Access Compliance Report

Public Rights-of-Way

(Curb Ramps)

Intersection ID: N/A	Main Street: PROVIDENCE_RD	Cross Street: N/A	Location: SE
ADA ID: 5F6C94513308	Ramp Type: PerpDiag	Initial Pass/Fail: Fail	Overall Compliance: No
			Severity Score: 21.25

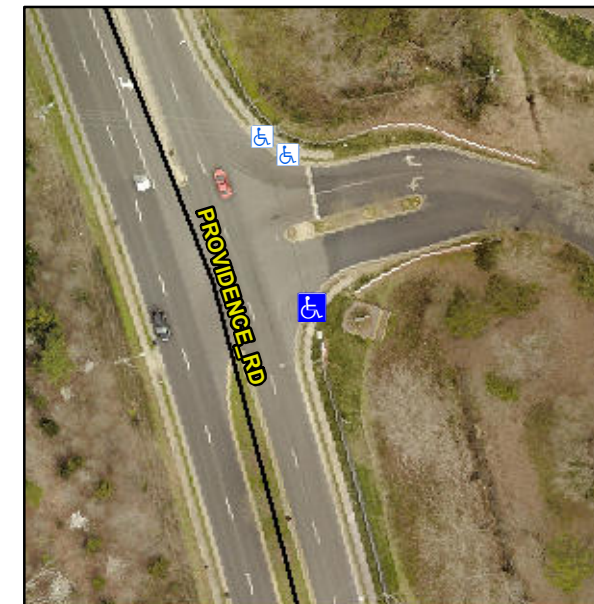
Not Found, R304.5.1, R304.5.3

Compliance	Description	Data	Compliance	Description	Data
N/A	Ramp Length (in)	69.0	Yes	Ramp Slope (%)	7.4
No	Ramp Width (in)	41.0	No	Ramp XSlope (%)	6.7
N/A	Flare Type LT	N/A	N/A	Flare Type RT	N/A
N/A	Flare Slope LT (%)	N/A	N/A	Flare Slope RT (%)	N/A
N/A	Flare Traversable LT?	N/A	N/A	Flare Traversable RT?	N/A
N/A	Landing Length (in)	N/A	N/A	DWS Provided?	N/A
N/A	Landing Width (in)	N/A	N/A	DWS Contrast?	N/A
N/A	Landing Slope (%)	N/A	N/A	DWS Length (in)	N/A
N/A	Landing X Slope (%)	N/A	N/A	DWS Full Width?	N/A
N/A	Landing Curb? (Y/N)	N/A	N/A	DWS Offset (in)	N/A
N/A	Shared Landing?	N/A			
N/A	Gutter Ponding?	N/A	N/A	Gutter Slope (%)	N/A
N/A	Gutter Lip Ht (in)	N/A	N/A	Gutter X Slope (%)	N/A
N/A	Painted X Walk1?	No	N/A	Painted X Walk2?	No
	X Walk 1 Direction	To N		X Walk 2 Direction	To W
N/A	X Walk 1 Width (in)	N/A	N/A	X Walk 2 Width (in)	N/A
	X Walk 1 Slope (%)	2.8		X Walk 2 Slope (%)	3.5
	X Walk 1 X Slope (%)	7.2		X Walk 2 X Slope (%)	1.9

Remove & Replace Curb Ramp With Two New Directional Ramps or Equivalent.
